UNITED STATES PATENT AND TRADEMARK OFFICE

APPLICATION NO.	FILING DATE	FIRST NAMED INVENTOR	ATTORNEY DOCKET NO.	CONFIRMATION NO.
10/705,597	11/10/2003	Anand Anandakumar	JA03-001	6241
28112	7590	09/28/2006	EXAMINER	
SAILE ACKERMAN LLC 28 DAVIS AVENUE POUGHKEEPSIE, NY 12603			CHAUDRY, MUJTABA M	
			ART UNIT	PAPER NUMBER
			2133

Office Action Summary	Application No. 10/705,597	Applicant(s) ANANDAKUMAR, ANAND	
	Examiner Mujtaba K. Chaudry	Art Unit 2133

DETAILED ACTION

**FIG.9**

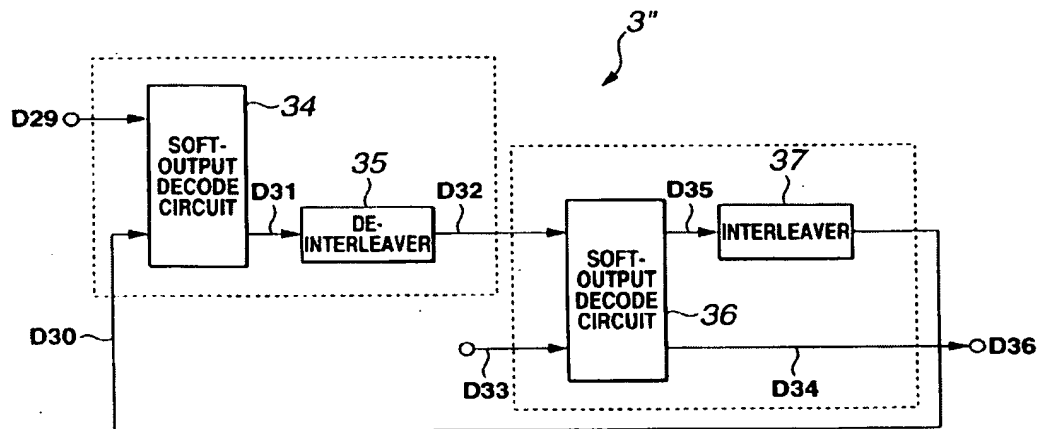
As per claim 1, Miyauchi substantially teaches a decoder for a communication system (i.e., Figure 1), the decoder comprising: a first decoder block (i.e., Figure 9, reference number 34 and paragraph 0280-0281) that receives a soft-input information bit for decoding and calculates a probability estimate for the soft-input information bit; a second decoder block (i.e., Figure 9, reference number 36 and paragraph 0280-0284) configured to receive and process the probability estimate of the soft-input information bit; and a decision module adapted to receive the processed soft-input information and to generate hard-decision output information (i.e., paragraph 0909).

As per claim 2, Miyauchi substantially teaches, in view of above rejections, (i.e., Figure 9 and Paragraph 0281) the first decoder block includes an output element configured to receive the soft-input information bit and to generate extrinsic information.
